City of Mississauga Department Comments

File(s): A63.22 Ward: 1

The applicant requests the Committee to approve a minor variance to allow an existing accessory structure with:

Property Address: 900 Atwater Avenue

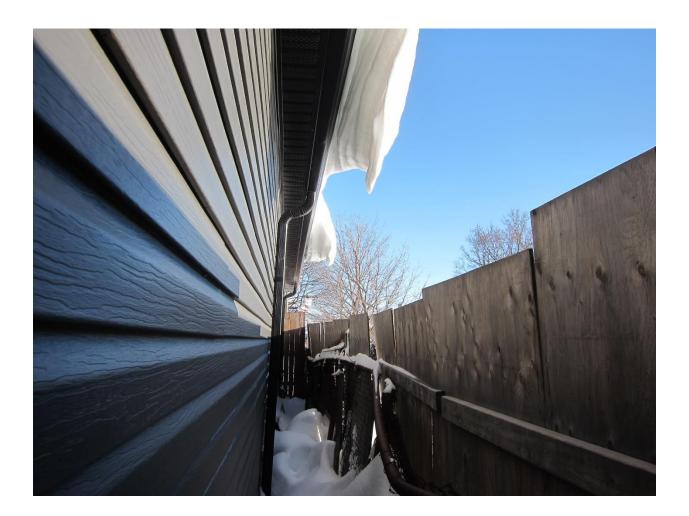
Enclosed for Committee's information are photos depicting the accessory structure. We draw attention to the photos of the rear side of the structure. All downspouts have been directed towards the neighboring property at the rear. All downspouts would need to be redirected to splash internally to the applicant's own lands in order to not impact the adjacent properties. Through the current Building Permit Application process (BP 9NEW 20/3296) our Development Construction Section is asking for further information regarding downspout locations, swale locations, setbacks, catch basin locations and existing elevations surrounding the property. This department suggests that the application be deferred until such time that the applicant has submitted a grading plan that clearly shows all of the requested information so that a determination can be made on the impact of the structure with regards to surface drainage.
